## Application for Licence Amendment

<b>Licence Number</b>	L7276/1996/12
<b>Licence Holder</b>	Murrin Murrin Operations Pty Ltd
<b>ACN</b>	076 717 505
<b>File Number</b>	2011/011705-1
<b>Premises</b>	Murrin Murrin Nickel Cobalt Project  Mining tenements: L39/62, L39/81, L39/83, L39/136, L39/168, M39/299, M39/300, M39/301, M39/314, M39/322, M39/421, M39/422, M39/423, M39/435, M39/436, M39/424, M39/342, M39/343, M39/446, M39/553, M39/562, M39/637, M39/651, M39/686, M39/692, M39/714, M39/715, M39/716, M39/737, M39/820  LAVERTON WA 6440  As defined in Schedule 1 of the licence
<b>Date of Report</b>	31 January 2023
<b>Decision</b>	Amendment Granted

**Figure 6. Groundwater levels recorded for monitoring bores surrounding 17 series in-pit TSF**

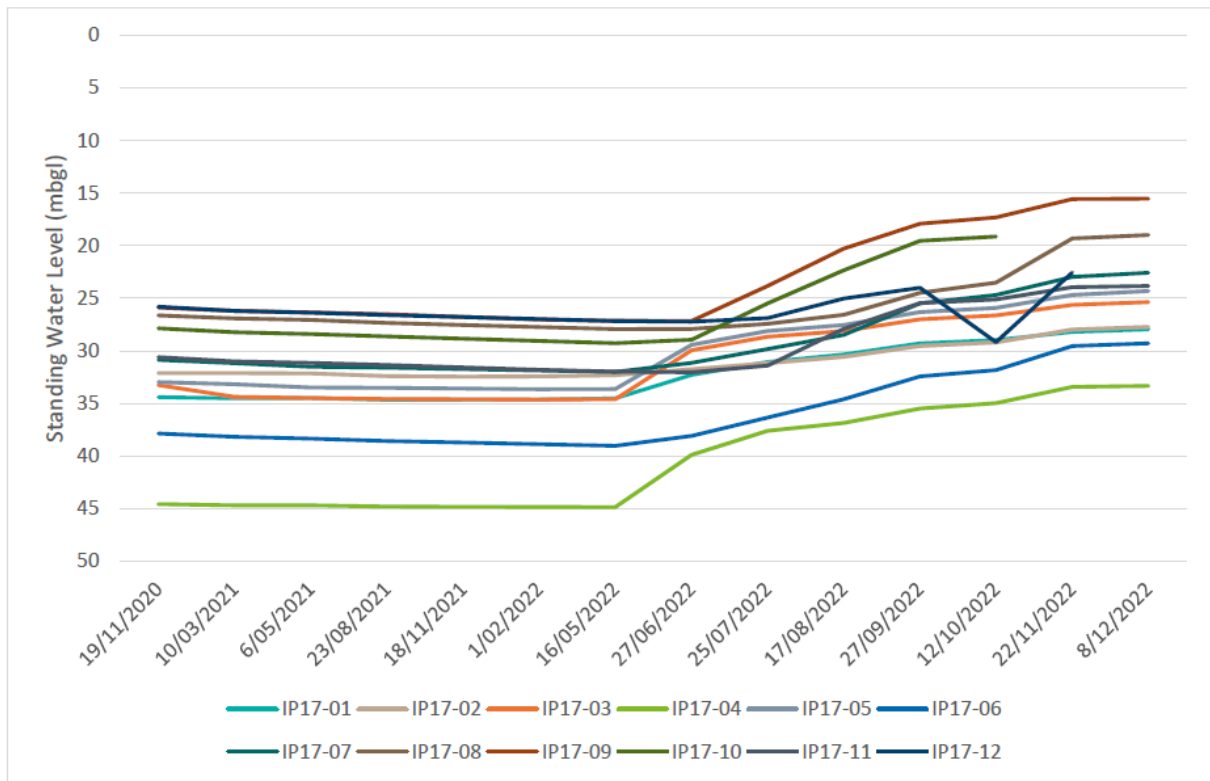
Groundwater depths in the twelve bores surrounding the 17 in-pit series TSF initially ranged between 25 and 45m bgl. Groundwater levels rose in all monitoring bores following commencement of tailings deposition in May 2022. Levels rose between 3 and 10 metres over five months of tailings deposition (Figure 6), where the shallowest groundwater level reported being 15.54 metres below ground level (m bgl).

**Figure 7. Total dissolved solids recorded for groundwater monitoring bores surrounding 17 series in-pit TSF during time limited operations**

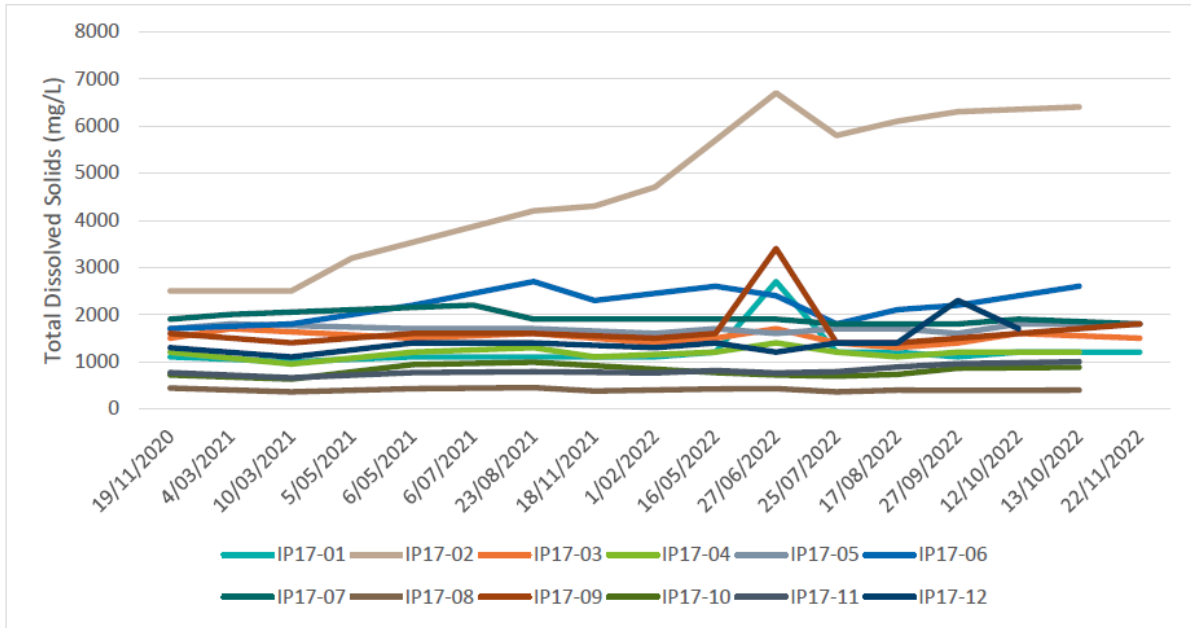
Groundwater salinity surrounding the 17 series pits has been increasing as a result of tailings deposition during time limited operations, particularly for IP17-02 – which increased from TDS 2,500mg/L in 2020 to 6,400mg/L in October 2022 (Figure 7).

**Figure 8. Nickel recorded for groundwater monitoring bores surrounding 17 series in-pit TSF during time limited operations**

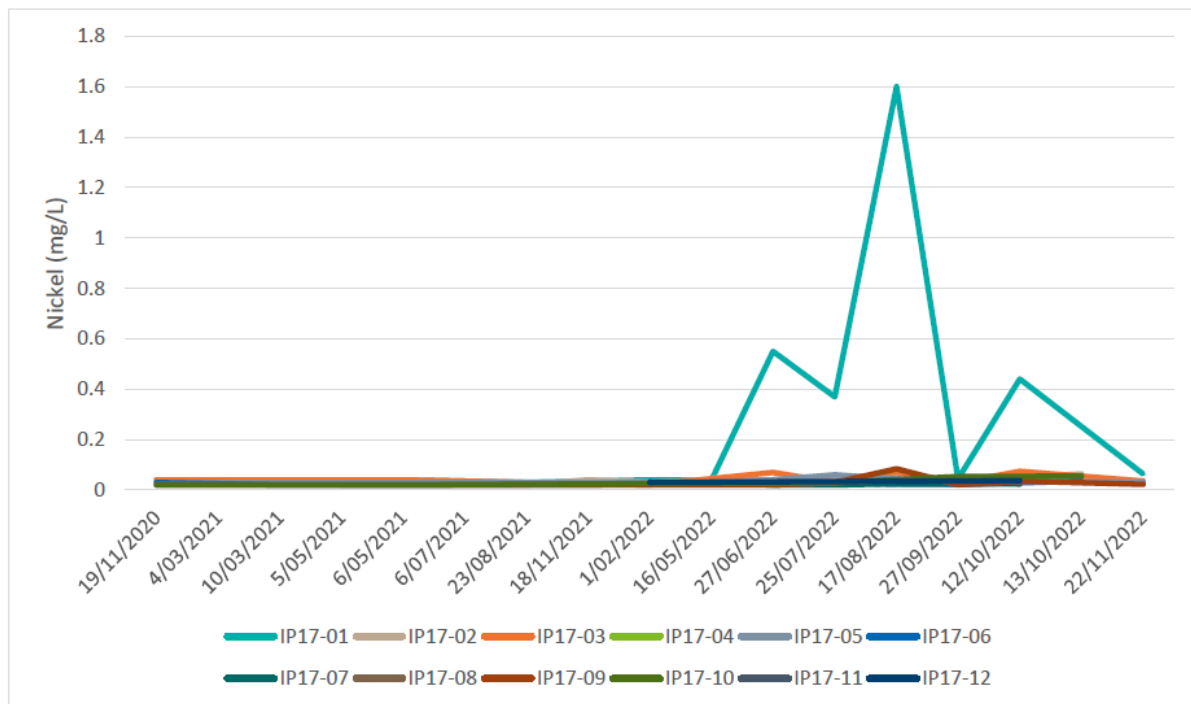
Nickel concentrations for monitoring bore IP17-01 increased to 1.6mg/L in August 2022, followed by a declining trend closer to baseline levels in November 2022. Other parameters did not change significantly from baseline during time limited operations.
